ADDENDUM NUMBER TWO

Schedule I (Federal)
Construct Airfield Lighting Vault

AIP Project No. 3-32-0005-049-2018
May 16, 2018

**ADDENDUM NO. 2
TO
CONTRACT DOCUMENTS, SPECIFICATIONS AND PLANS
FOR IMPROVEMENTS TO THE
ELKO REGIONAL AIRPORT
ELKO, NEVADA
AIP PROJECT NO. 3-32-0005-049-2018**

**ELECTRICAL VAULT BUILDING
ELEVATIONS**

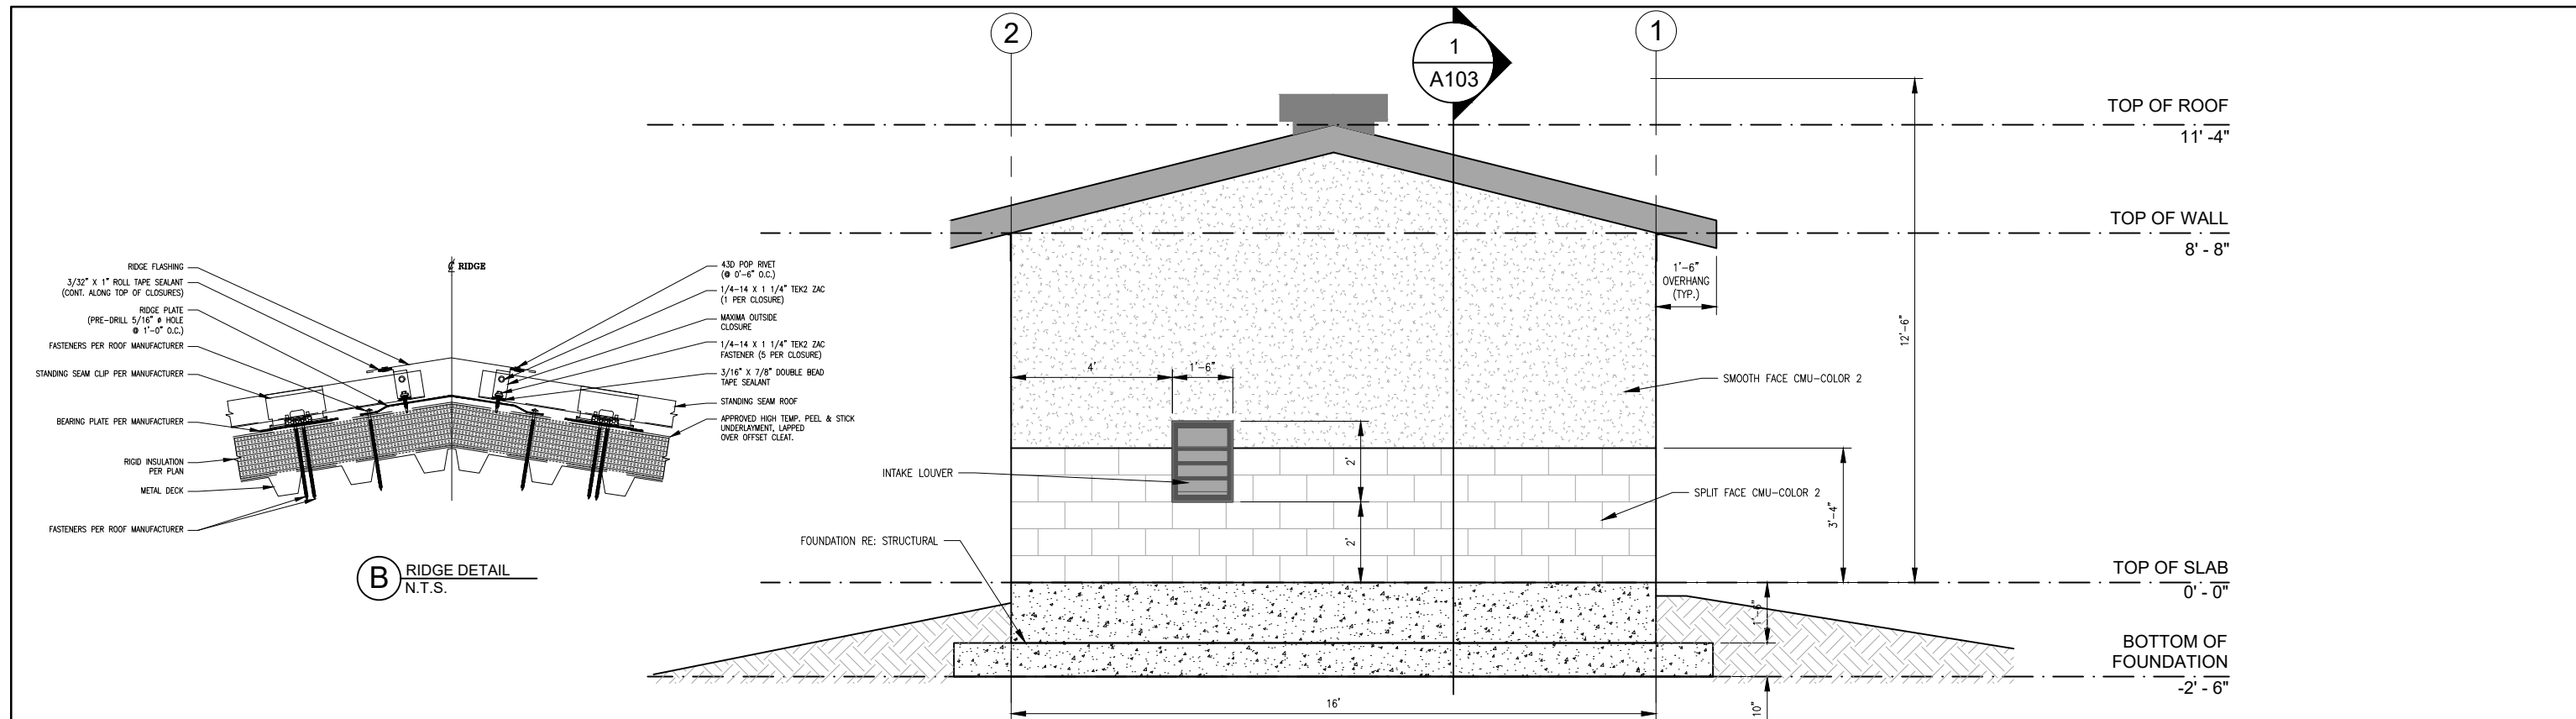
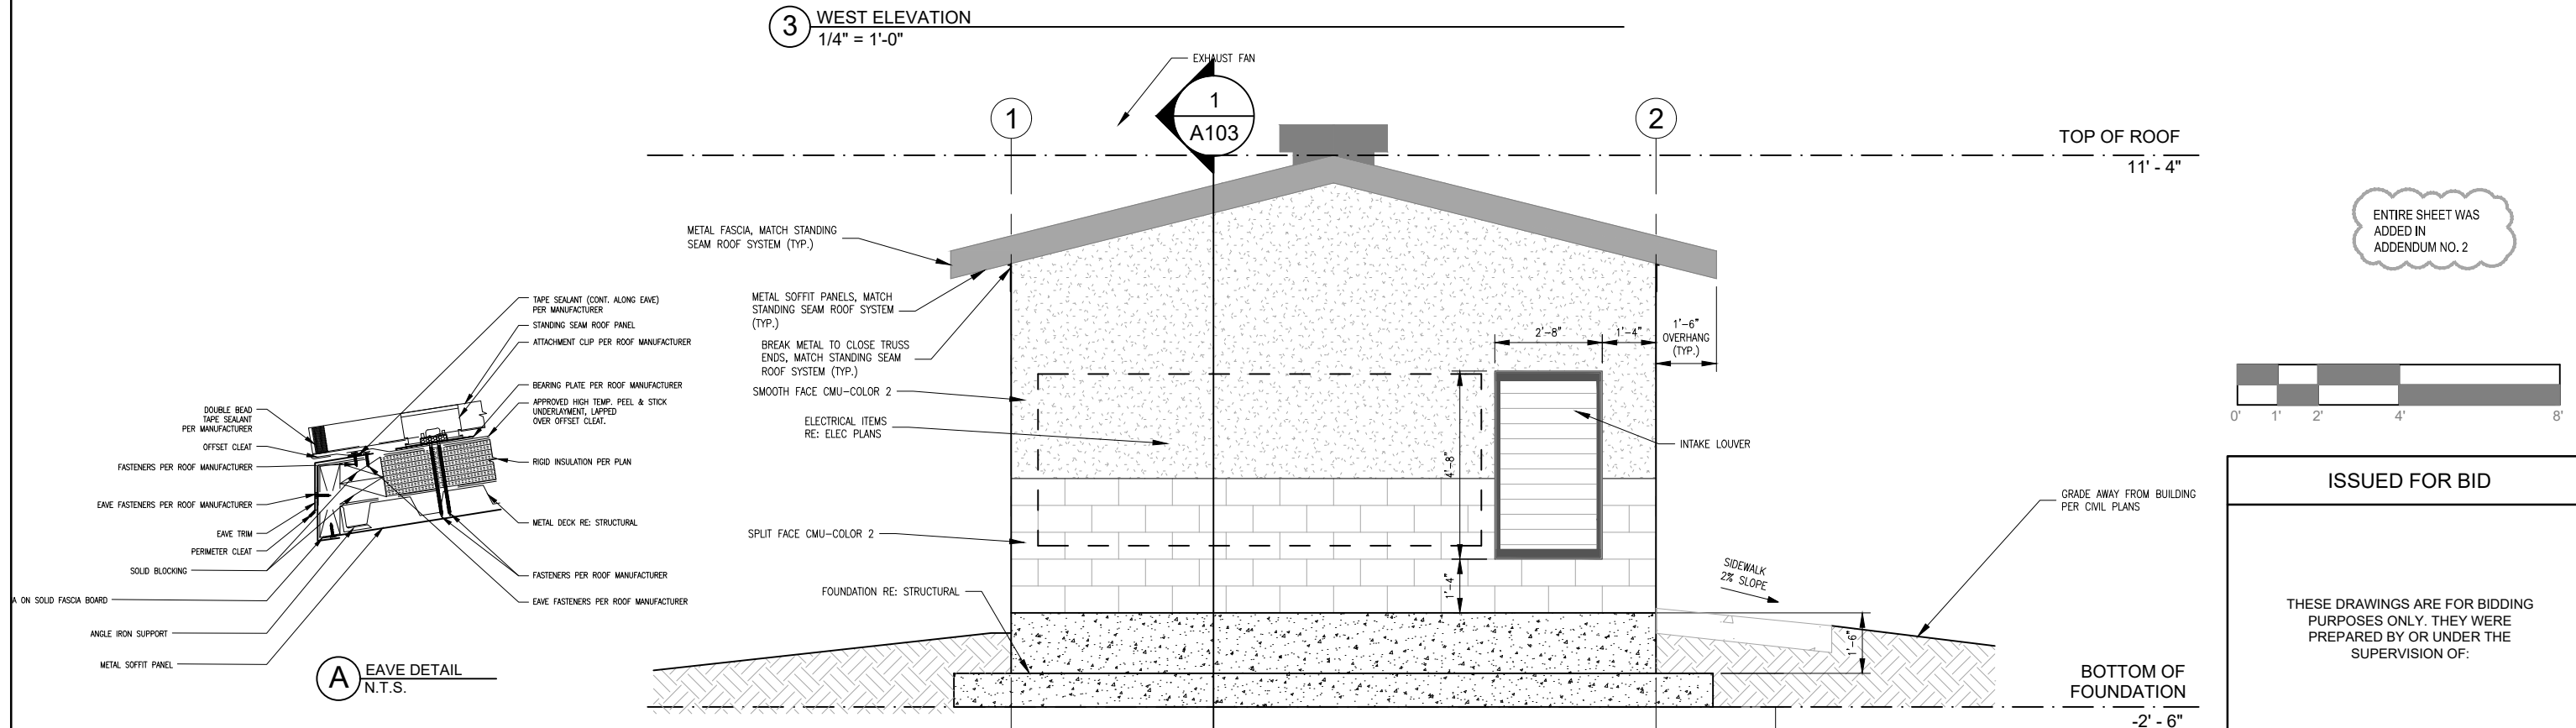
A102 – The plan set contained sheet A101, Sheet 15 of 24, in the set twice. Replace the 2nd A101 with the attached A102, Sheet 16 of 24.
